The Fourth Technical Committee was appointed by the USACE to conduct an assessment and evaluation of the accounting procedures and methodology used in the determination of diversion from Lake Michigan and to ascertain whether or not the methods are in accordance with the best current engineering practice and scientific knowledge, as stipulated in the 1980 modified Decree of the U.S. Supreme Court. This review is to be performed by a Technical Committee appointed every five years, and a report evaluating the accounting and operational procedures is to be presented to the USACE and to other interested parties.

The Fourth Technical Committee was appointed by the USACE in July of 1998 and convened in September of 1998. The Committee was appointed to conduct a comprehensive review of the current diversion accounting procedures. The review included the following: 1.) current accounting results; 2.) current diversion related measurement techniques at the Romeoville acoustic velocity meter (AVM) site, the Lockport control structures, precipitation gages, and other pertinent structures; 3.) procedures used to calculate and verify flows that are not directly measured; and 4.) status of reco

Figure 2.5-a: Differences in water-supply pumpage estimated by equations for diversion accounting and for *Lakefront Accounting Technical Analysis*

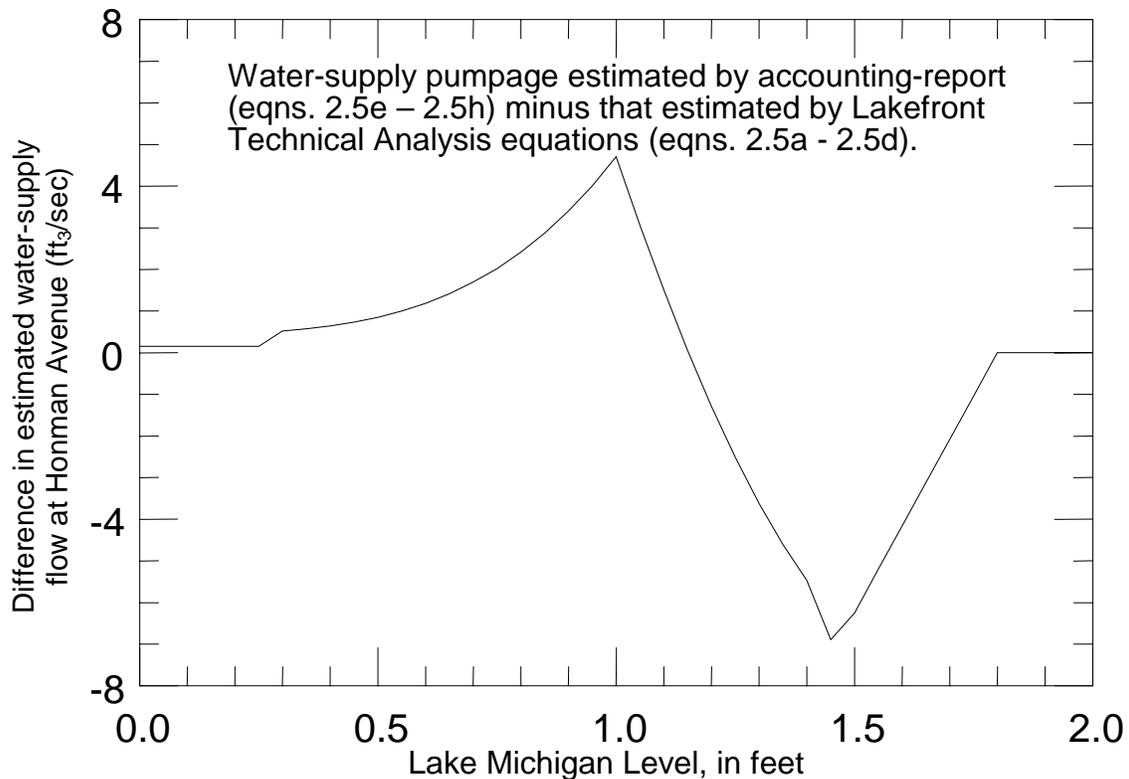
For Lake Michigan levels near 1.0 ft CCD, the equations used in the accounting reports estimate about 4.0 ft³/sec more flow than the equations used in the *Lakefront Accounting Technical Analysis*. For Lake Michigan levels near 1.5 ft CCD, the equations used in the accounting reports estimate about 6.9 ft³/sec less flow than the equations used in the *Lakefront Accounting Technical Analysis*. This corresponds to errors of –30 percent to +17 percent of the typical annual water-supply pumpage at Hohman Avenue. Figure 2.5-a shows the differences between the two sets of equations for the range of Lake Michigan levels. The potential long-term effect of the differences between these equations was evaluated by evaluating the differences for Lake Michigan levels from January 1996 through August 1998. The average difference in estimated water-supply pumpage past Hohman Avenue was 1.6 ft³/sec less flow was estimated by Equations 2.5-e through 2.5-h than by Equations 2.5-a through 2.5-d.

The Technical Committee recommends that the basis for the equations used in the *Lakefront Accounting Technical Analysis* (USACE, 1996a) and the water year accounting reports, as well as the basis for using different equations for Romeoville and lakefront accounting, be defined clearly.

Figure 2.5-c: Double-mass-curve comparison of Indiana water-supply pumpage and Lake Michigan pumpage accountable to Illinois, water years 1989 through 1995.

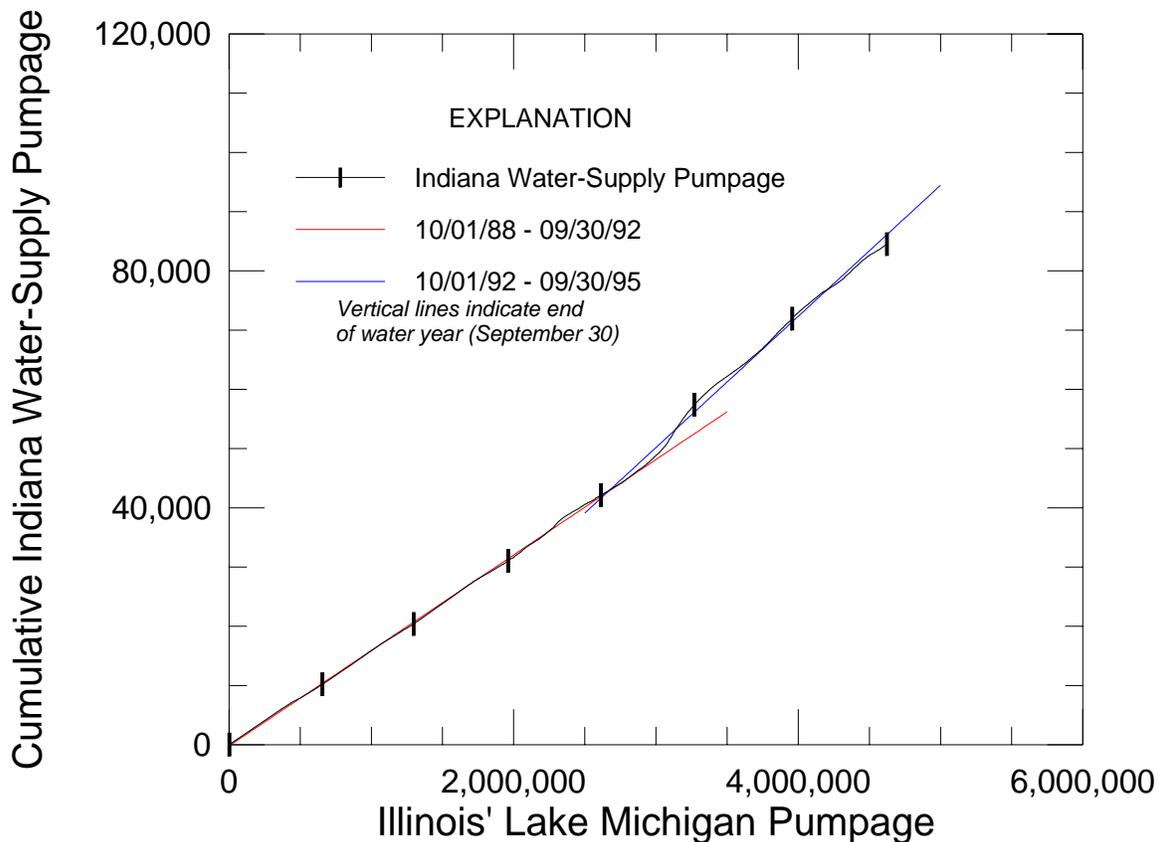
Beginning in water year 1993 (October 1, 1992), the accounting procedure for Indiana pumpage discharged to the CSSC was changed as described above. The average annual Indiana pumpage discharged to the CSSC from water years 1989 through 1992 was 28.8 ft³/sec. The average annual Indiana pumpage discharged to the CSSC from water years 1993 through 1995 was 38.7 ft³/sec, an increase of 34.7 percent. Although other factors, such as the level of Lake Michigan, may have changed Indiana's pumpage discharged to the CSSC at this time, they are not identified in the accounting reports. If the change in procedure is the cause of the change in Indiana pumpage discharged to the CSSC, and the new procedure is accepted as more accurate, the accounting for water years prior to 1993 should be reviewed.

Figure 3.2-f - Comparison between simulated and observed flow at the Hodgkins (mainstream) TARP pumping station for 1995.

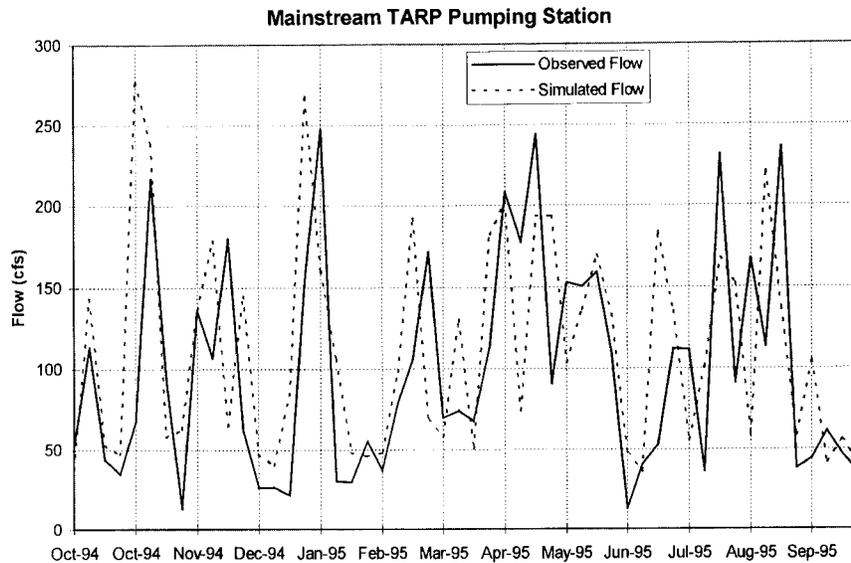
Figure 3.2-f compares simulated and observed flow at the Hodgkins TARP pumping station for 1995. For the TARP system, the groundwater flow of 55 ft³/sec is about 50 percent of the total inflow into the tunnels. The Technical Committee recommends that the USACE investigate reducing the groundwater inflow and increasing the inflow to the tunnel by postponing the closure of the drop shaft gates. The latter can be accomplished by increasing the elevations at the index stations when the drop shaft gates close. Calibrating by storm event may also improve the simulation of the individual events. This procedure would divide the time series into a series of events. The model parameters are assumed constant over the event and the parameters are optimized to provide the best simulation of the event. This is a technique that is used on period-of-record simulation of large rivers, where hydrologic parameters are not constant. The technique does provide a better answer, but at increased work. For the diversion-accounting problem, where an annual flow is all that is required, the procedure will not improve the annual number, but it will improve the overall simulation.

Another problem is the starting tunnel storage. The TNET program pumps down the tunnel when the water level exceeds a starting elevation; thus the tunnel may be above minimum storage at the start of an event. At the forecast of significant runoff, MWDRGC pumps down the tunnel, hence, the tunnel is always at minimum storage at the start of an event. Adding a forecast capability to the TNET program would pump the tunnel down prior to an event.

Figure 3.2-g - Comparison between simulated and observed flow at the Calumet pumping station for 1995.

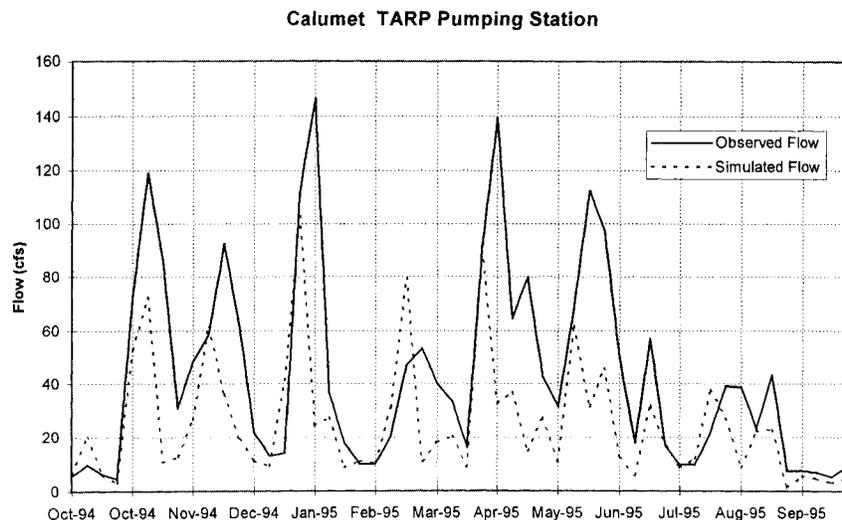
The Calumet model is a more complex problem. Figure 3.2-g compares simulated and observed flow at the TARP pumping station for 1995. The pump-station algorithm of the TNET program was developed for the TARP pump station and not the Calumet pumping station; therefore, the timing of the pumping may be improper. The pump-station algorithm will not effect the overall volume of the pumping. The USACE has contracted to upgrade the pump-station algorithm. There is a deficiency of volume entering the tunnels, both during base flow and during storm events. The inflow can be increased by postponing the closure of the drop shaft gates and by increasing the groundwater flow into the tunnels. Secondly, the sewer connections to the tunnel and should be checked to ensure that all inflow enters the tunnel. The Calumet pumping station has no impact on the diversion accounting flow since the overflows from the drop shaft gates are returned to the canal system.

Figure 3.2-h - Double-mass-curve comparison of runoff from the Des Plaines River watershed reaching the canal and precipitation, water years 1990 through 1995.

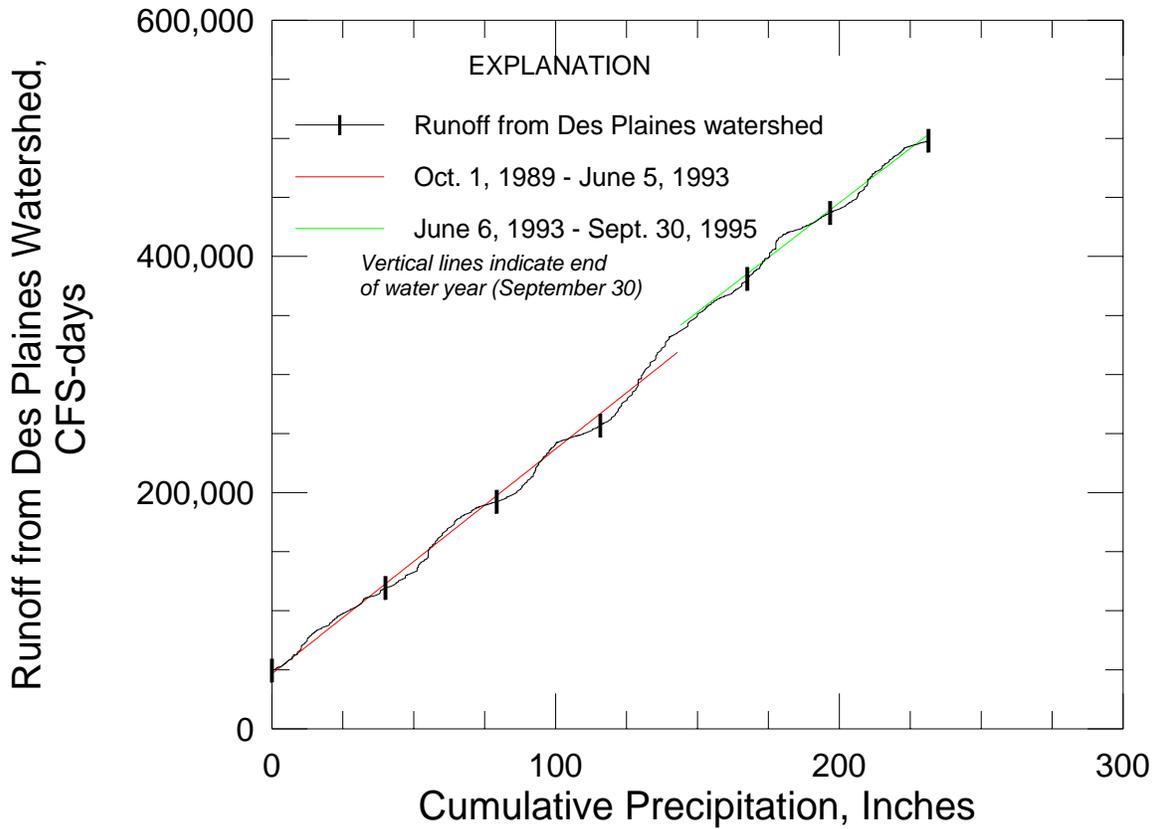
Double-mass curves were used to compare computed runoff components with the average precipitation for water years 1990 through 1995. The double-mass curve comparing the runoff from the Des Plaines River watershed that reaches the CSSC (Column 6 of diversion-accounting table) with the precipitation (Figure 3.2-h) shows a break in the slope near the end of water-year 1993. Linear regression was used to fit straight lines to the data prior to and after the southern and middle portions of the Des Plaines TARP system were placed into service (June 6, 1993). The break in the slope of the curve indicates that, on the average, the modeled runoff from the Des Plaines watershed from a unit rainfall has decreased three percent since June, 1993. As double-mass curves provide a more qualitative, rather than quantitative analysis, this break may be the result of one or several of the changes in the accounting system around this period.

Figure 3.2-i - Double-mass-curve comparison of runoff from the diverted Lake Michigan watershed and precipitation, water years 1990 through 1995.

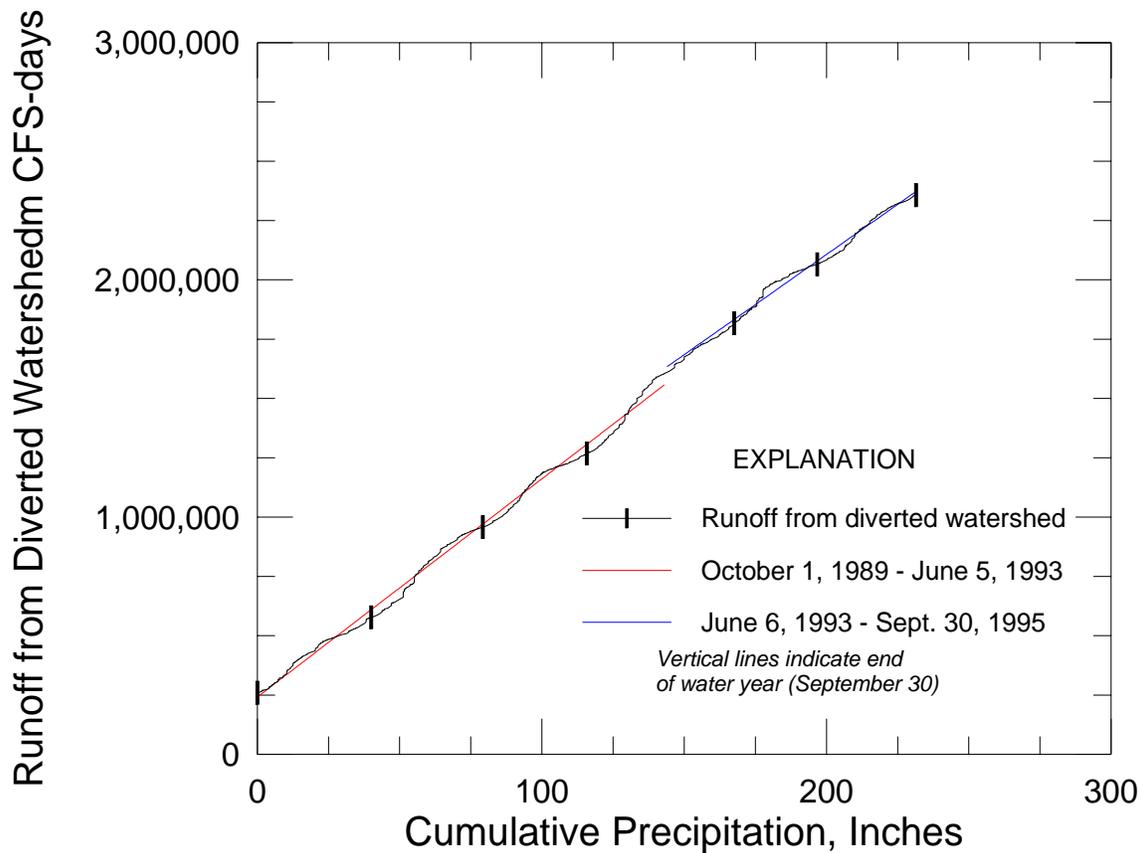
A double-mass curve comparing the runoff from the diverted Lake Michigan watershed (Column 12 of diversion-accounting table) with the precipitation (Figure 3.2-i) for the same period showed a similar break in slope. Linear regression was used to fit straight lines to the data prior to and after June 6, 1993. The slopes of the curves before and after this date showed that the runoff from a unit rainfall decreased approximately eight percent after June 6, 1993. This indicates that the revisions to the diversion-accounting methods around this period adjusted the modeled relation between rainfall and runoff, and that the break in the runoff from the Des Plaines watershed reflected this overall change in the rainfall-runoff relation, as well as the increased runoff from bringing the Des Plaines TARP system on-line.

Figure 4.2-a - Record of water elevations and AVM velocities from the Calumet River at O'Brien Locks and Dam, October, 1997 through December, 1998.

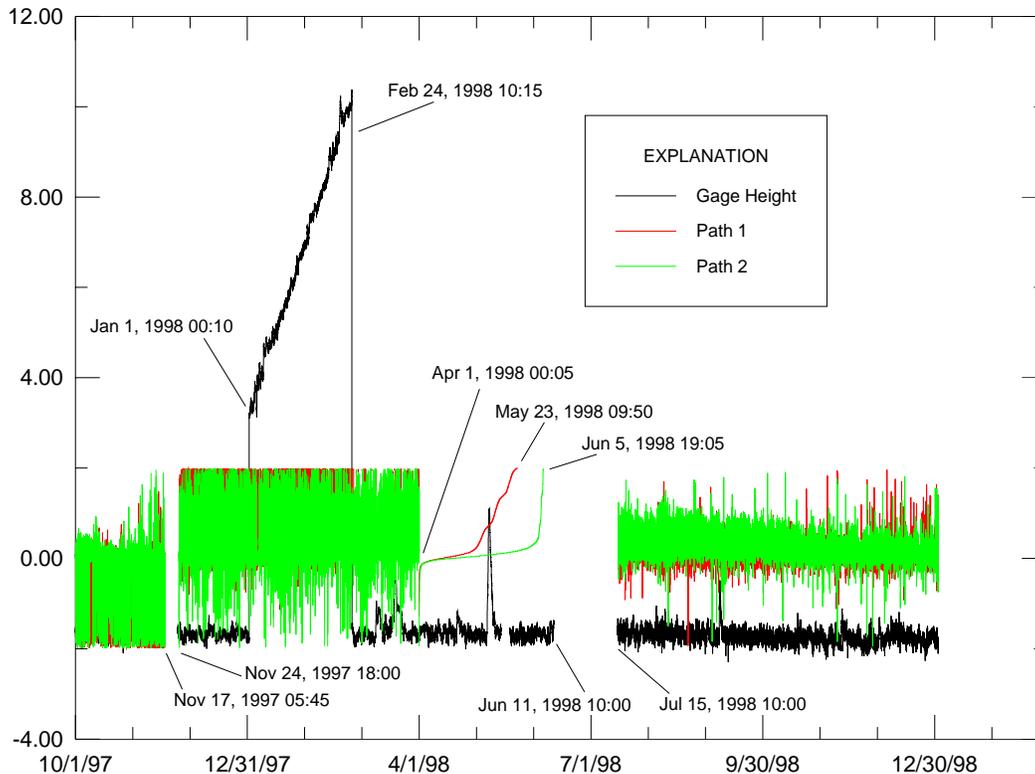
Analysis of the time-series record of water-surface elevation and AVM velocities for the station at O’Brien Lock and Dam indicates that much of the record may not be suitable for analysis. Data are missing for large periods of the record. It also appears that sensors were adjusted or malfunctioning at times during the record. Figure 4.2-a shows time-series record of water-surface elevation and AVM velocities for this site. It appears that when the site was returned to operation on November 24, 1997, the distribution of measured path velocities was different than for the period prior to November 17, 1997. The stage sensor was not operating correctly from January 1, 1998 through February 24, 1998. It appears that the AVM began to malfunction on April 1, 1998 and this continued until the path velocities were out of range on May 23 (Path 1) and June 5 (Path 2). The AVM was returned to service on July 15, 1998 and appears to have functioned correctly from that time through December 31, 1998.

It also appears that the AVM is set to 'clip' data exceeding ± 2.00 ft/sec. Velocities of this magnitude are unreasonable for this site, so this is reasonable to screen the data; however, the missing values affect the filtering used to further analyze the data. Therefore, while the following paragraphs give an estimate of the noise in the data, this estimate is based on analysis of an incomplete record and therefore is only an approximation.

Figure 4.2-b - Graph showing measured and filtered AVM velocities and mean velocities from ADCP measurements at the O'Brien Locks and Dam AVM site, November 5, 1997.

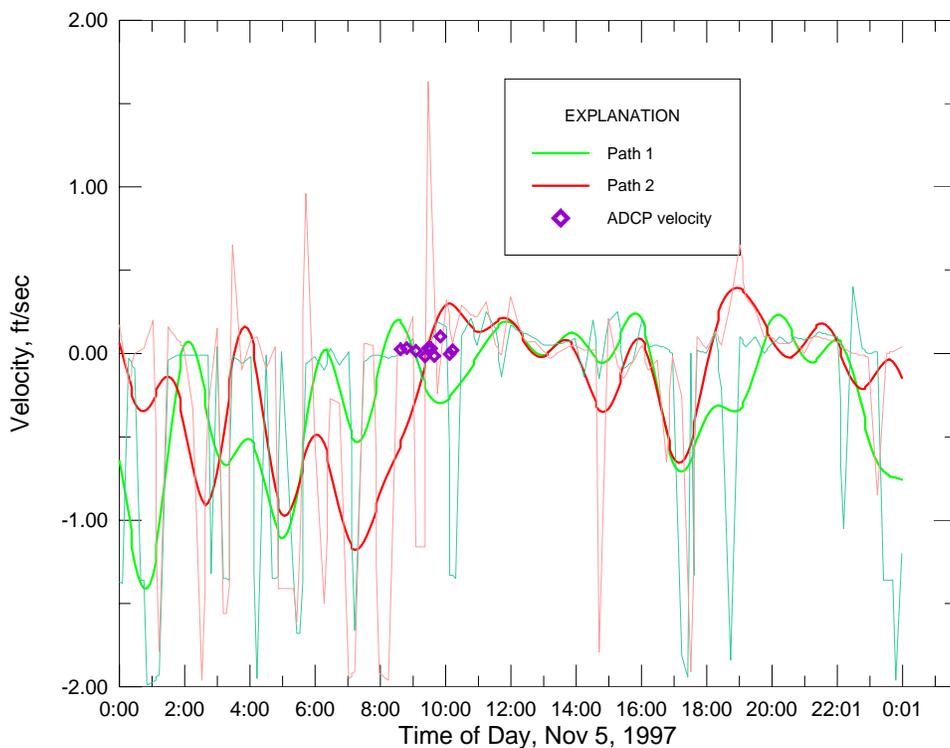
Analysis of the time-series record of AVM velocities for this site indicates a great deal of 'noise' in the measurements. Graphical analysis of the data indicated an apparent signal overlain with noise as large as ± 1.5 ft/sec (Figure 4.2-b). The data were filtered to attempt to remove the noise from the underlying signal. Data for each day of ADCP measurements, as well as for the 12 hours preceding and following that day were selected for filtering and analysis. A linear trend was fit to the data, and then subtracted from the time-series record to make the data 'stationary.' A low-pass filter was then used to remove frequencies greater than 0.5 hour^{-1} . The linear trend was then added back to the filtered record to produce a final estimate of the long-term 'true' AVM velocities with the high-frequency noise removed. This analysis was intended to provide data to examine the potential accuracy of the discharges at this site. If a similar approach is used to develop an operational rating for the site, a more thorough analysis is needed to: (1) determine if a filter is appropriate; (2) to select an appropriate filter; and (3) to quantify the error introduced by the filter. Figure 4.2-b shows the AVM velocities for November 5, 1997, the filtered AVM velocities, and the mean velocities from ADCP measurements.

The noise in the 5-minute AVM record at this site is significant. The filtering described above was done for every day with ADCP measurements. The root-mean-square (RMS) of the difference between the measured path velocities and the filtered path velocities for the entire data set was calculated as a measure of the noise in the data. The RMS differences for paths 1 and 2 were 0.337 and 0.322 ft/sec, respectively. This is compared to median velocities for these paths of 0.030 and 0.070 ft/sec, respectively, for the same data. The median discharge from three days that flow measurements were done was 500 ft³/sec, which corresponds to a channel velocity of 0.10 ft/sec. Given the low velocities typical of this site, the magnitude of the noise in the AVM velocities often exceeded the mean velocity at this site. A method should be developed to filter the AVM record to improve the interpretation of these data.

Figure 4.2-e - Graph showing measured and filtered AVM velocities and mean velocities from ADCP measurements at the Columbus Avenue AVM site, September 16, 1997.

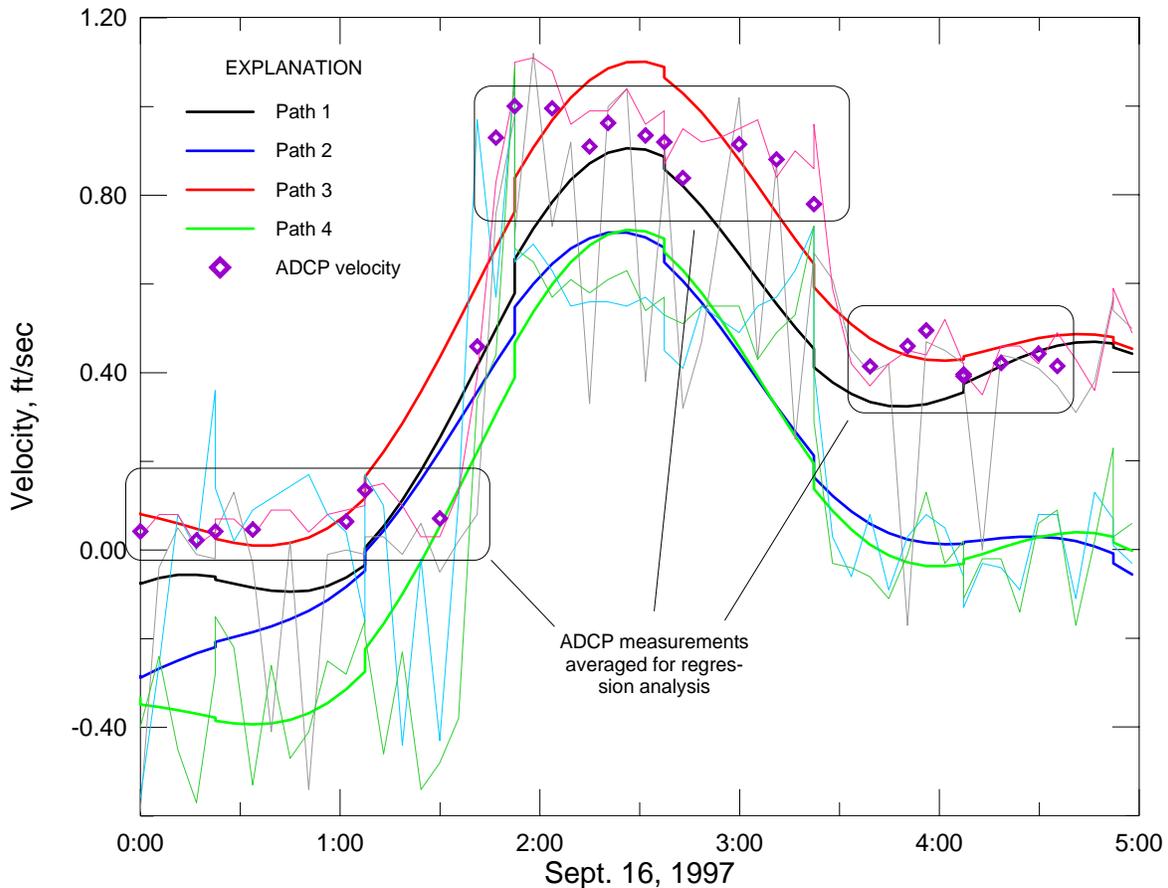
Analysis of the time-series record of AVM velocities for this site indicated a great deal of ‘noise’ in the measurements. Graphical analysis of the data indicated an apparent signal overlain with noise as large a ± 0.40 ft/sec (Figure 4.2-e). The data were filtered to attempt to remove the noise from the underlying signal. Data for each day of ADCP measurements, as well as for the 12 hours preceding and following

The noise in the 5-minute AVM record at this site is significant. The filtering described above was done for every day with ADCP measurements. The RMS of the difference between the measured path velocities and the filtered path velocities for the entire data set was calculated as a measure of the noise in the data. The RMS differences for paths 1 through 4 were 0.211, 0.304, 0.158, and 0.221 ft/sec, respectively. This is compared to mean velocities for these paths of 0.030, -0.042, 0.062, and 0.049 ft/sec, respectively, for the same data. The median cross-sectional area of the channel is $4,700 \text{ ft}^2$. The median discharge from seventeen days that flow measurements were done was $360 \text{ ft}^3/\text{sec}$, which corresponds to a channel velocity of 0.08 ft/sec . Given the low velocities typical of this site, the magnitude of the noise in the AVM velocities often exceeded the mean velocity at this site. A method should be developed to filter the AVM record to improve the interpretation of these data.
